City of Lone Tree Planning Commission Agenda Tuesday, February 11, 2014

SUBJECT: RidgeGate Section 15, Filing 11, 2nd Amendment
Site Improvement Plan (Commonwealth Heights), Project #SP13-52R

Approval of a Site Improvement Plan (SIP) for a four-story multi-family residential building consisting of 190 multi-family units and 8,210 square feet of ground floor retail on 3.25 acres.

**EXISTING
 CONDITIONS
 PLAN**

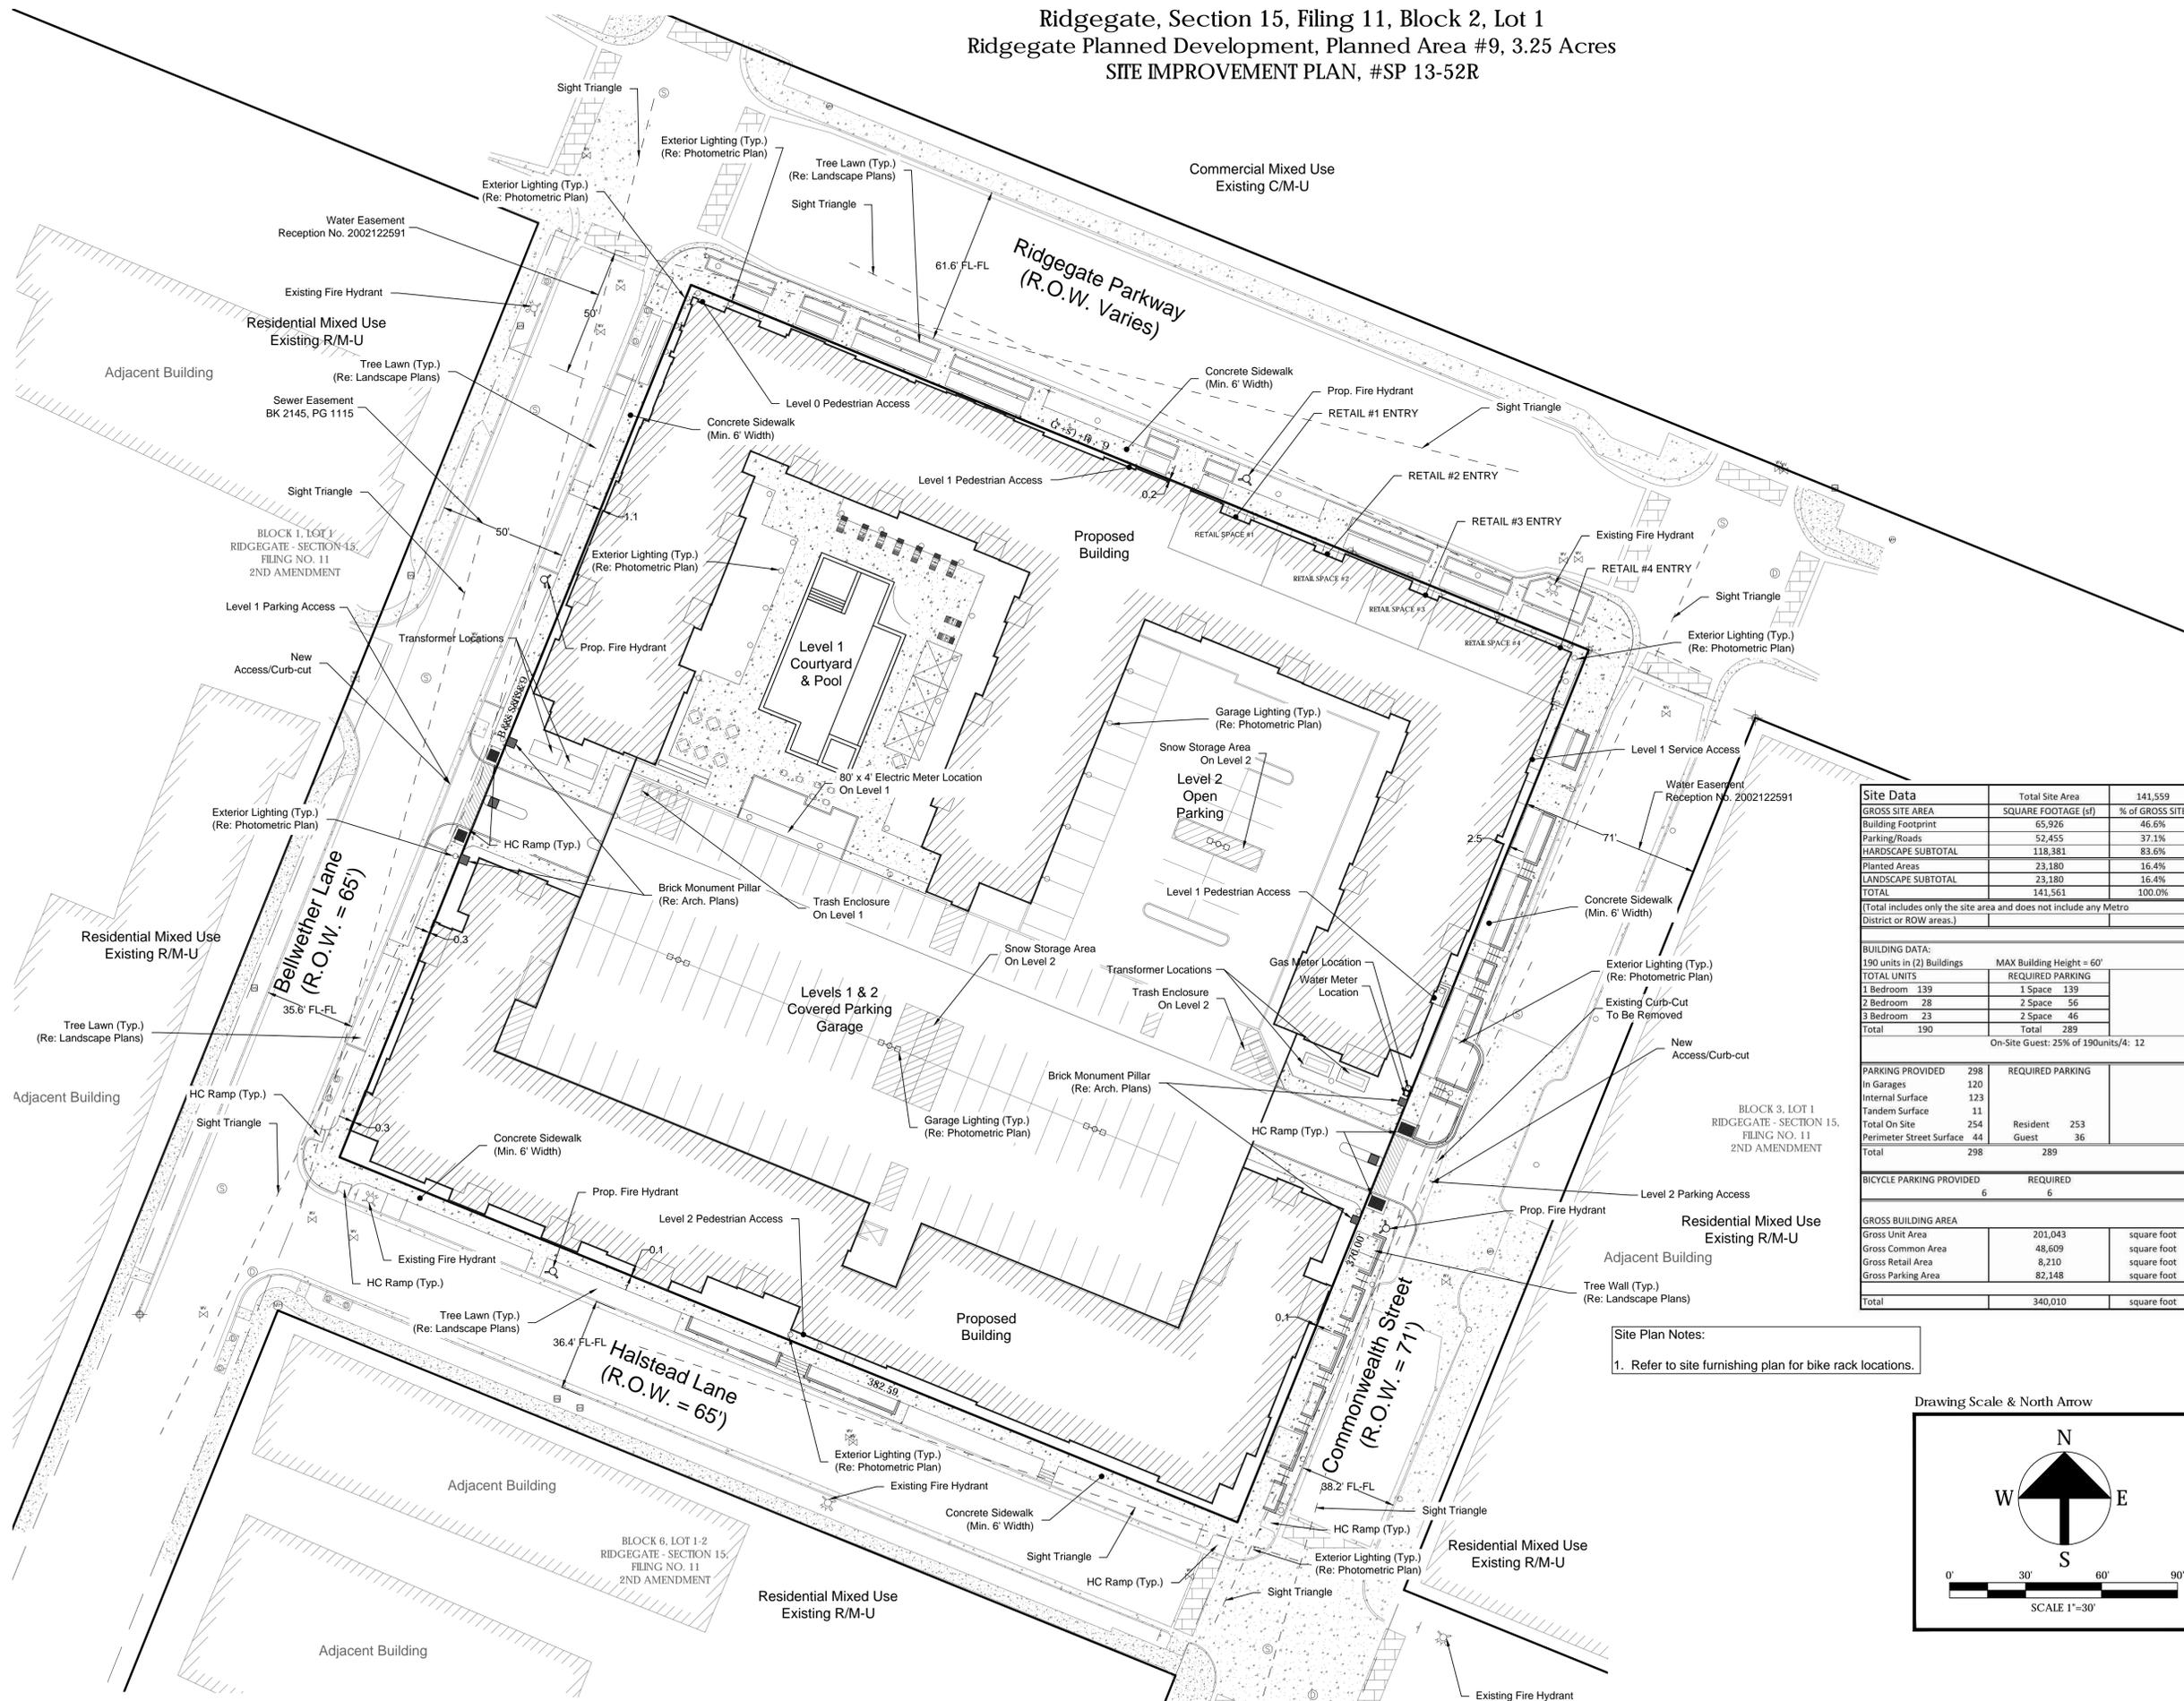
PSCo also requests that the gas pipeline be shown on the Existing Conditions Plan Sheet C1-0.

SITE PLAN
C2-0
 SHEET 3 OF 24

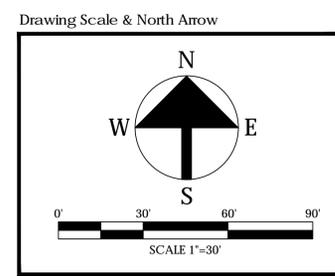
4. A number of non-standard landscaping features are proposed within the ROW (such as Tree Walls in Commonwealth Street and Halstead Lane ROW’s, and what appears to be curbed or walled planter areas in RidgeGate Parkway ROW). Additionally, based on the limited set-back of the building from the lot line/ROW line, there also may be some encroachments across the ROW line from building overhangs/attachments (such as entry awnings etc.). The ROW line should be clearly shown on all sheets, and any such proposed “building encroachments” should be identified. An appropriate License Agreement addressing the non-standard planters/walls and any building encroachments in the ROW will need to be developed and executed between the Owner/Developer and the City, prior to final engineering approvals and final SIP approval.

L1-1
7 of 24

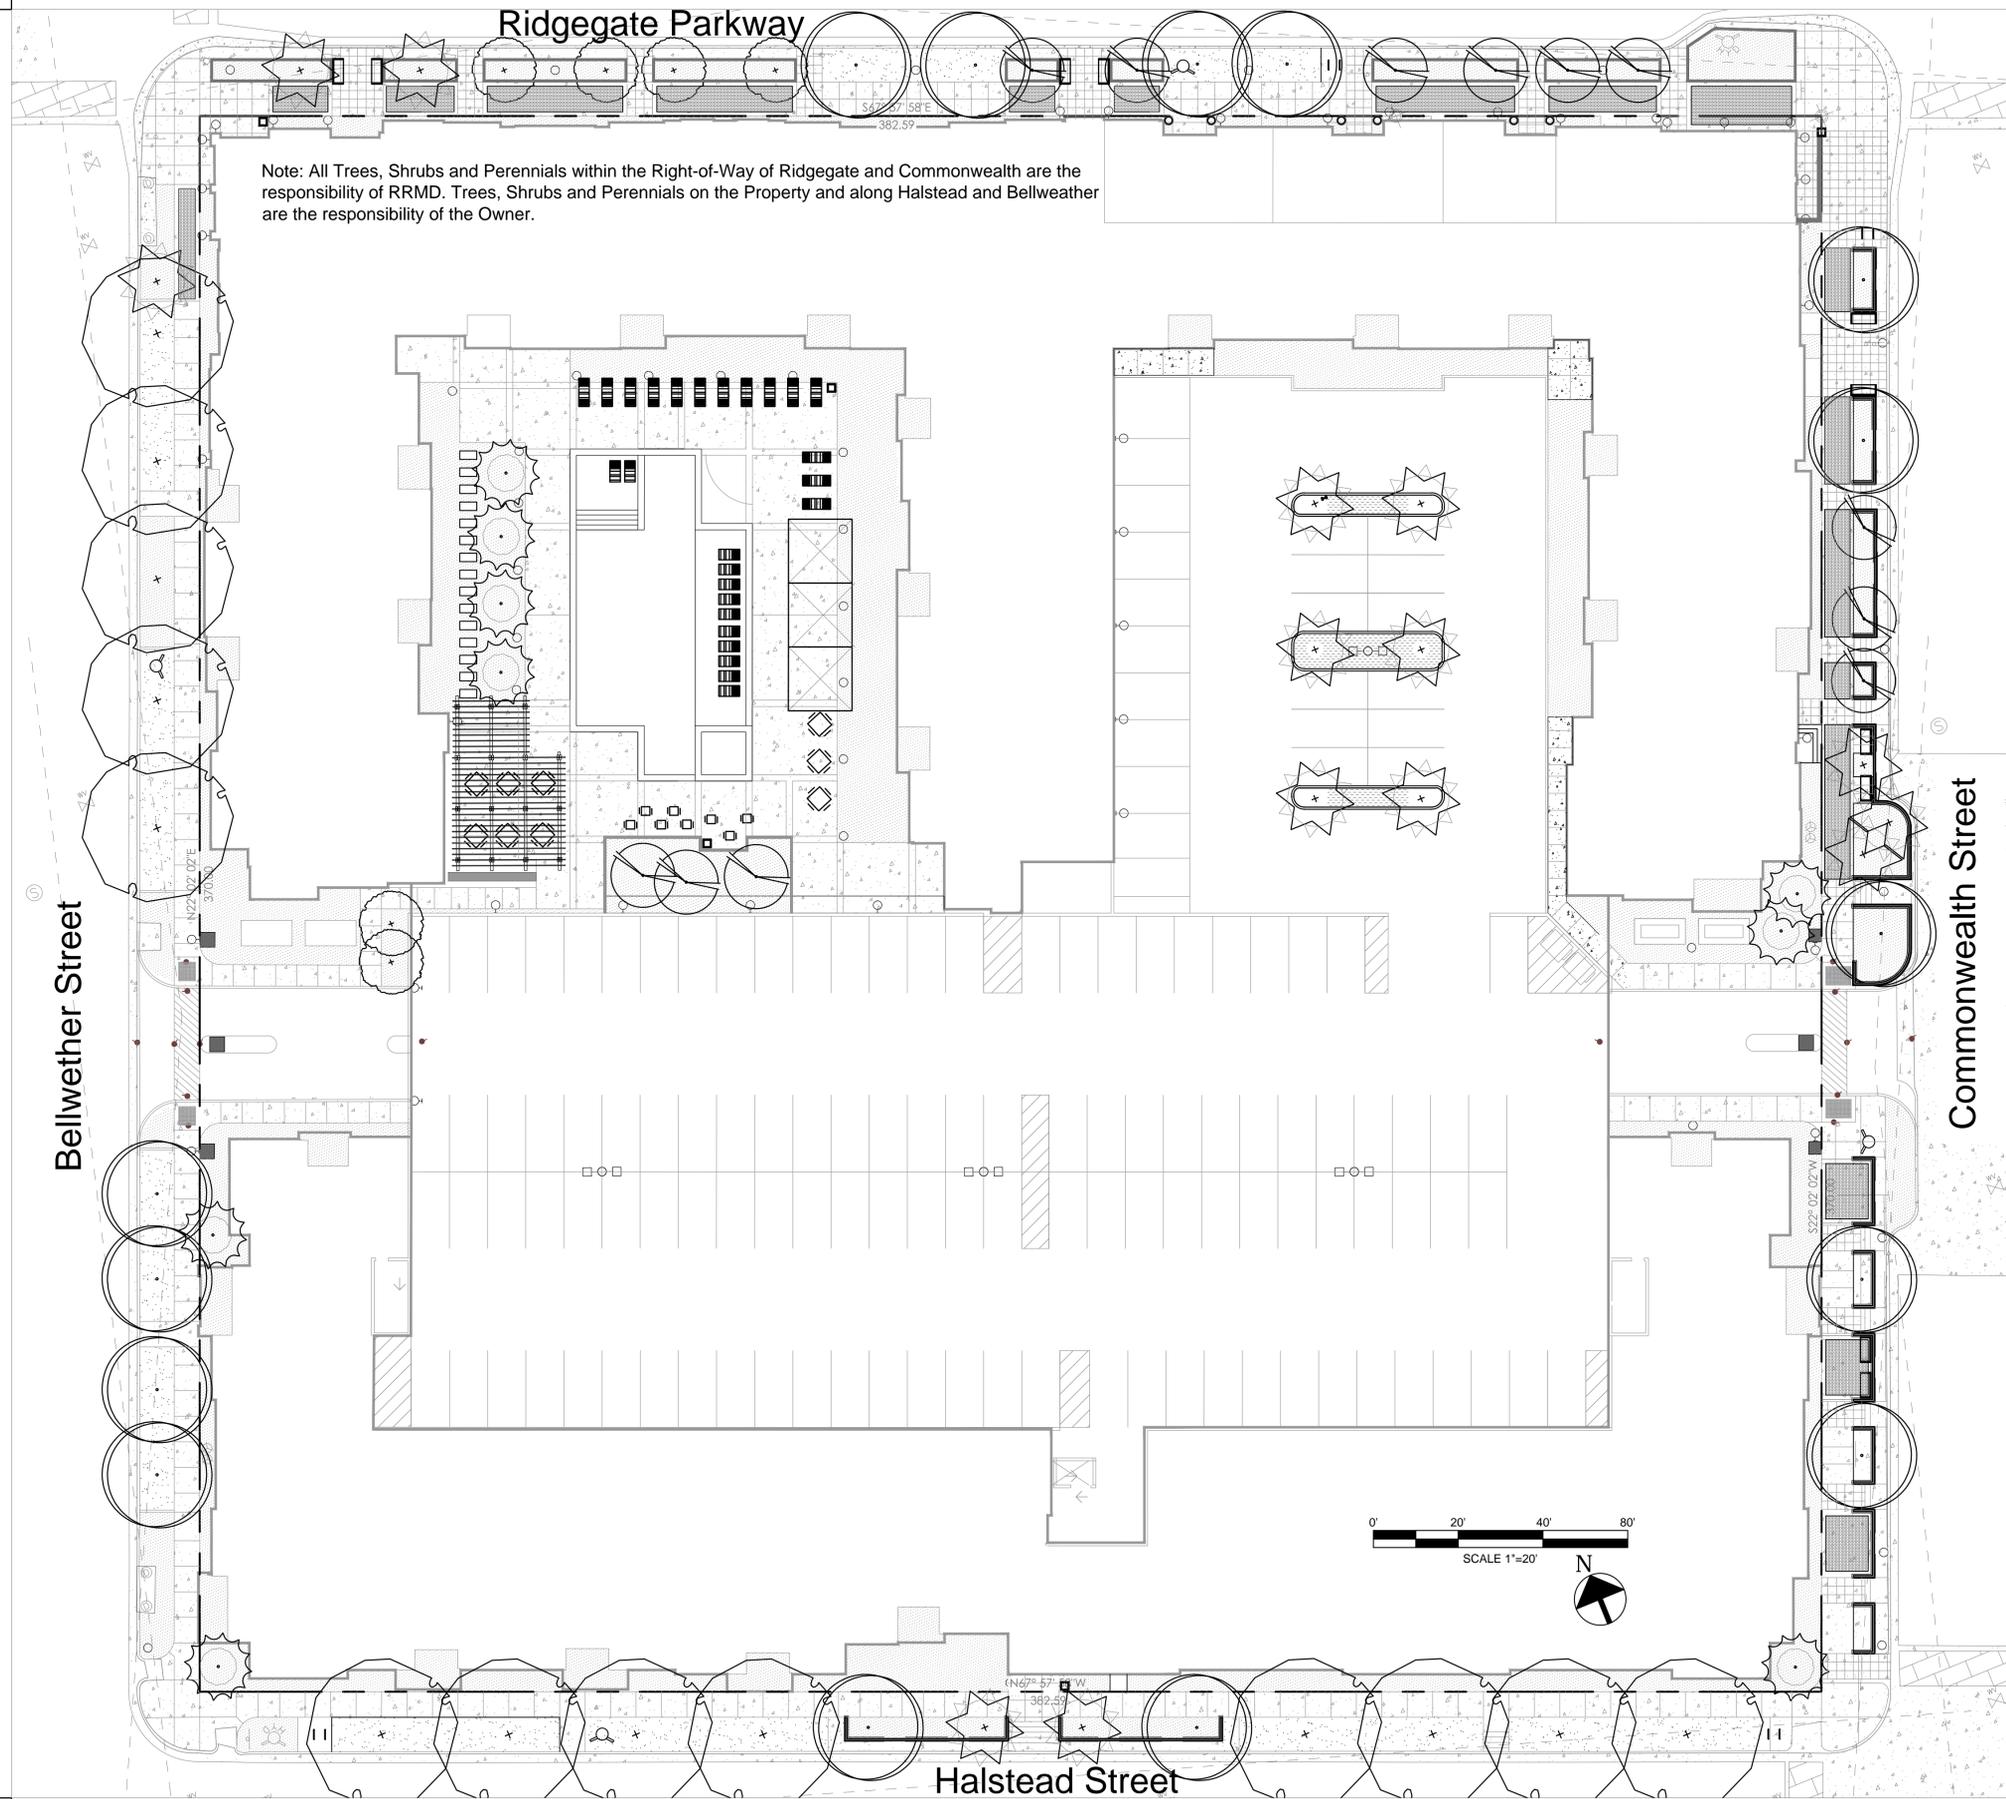
6. A number of call-outs are indicated with standard abbreviations, however an appropriate abbreviations “Key” is not provided on this sheet. Instead, the applicable “Key” is provided on a subsequent sheet. It would be helpful if either the “Key” was provided on this sheet, or if a note is added directing to the location of the applicable Key. (Note: This same type of occurrence/need for a note directing to the applicable “Key” also occurs on Sheets L-2.0 (11 of 34) and E1-1 (31 of 34).)
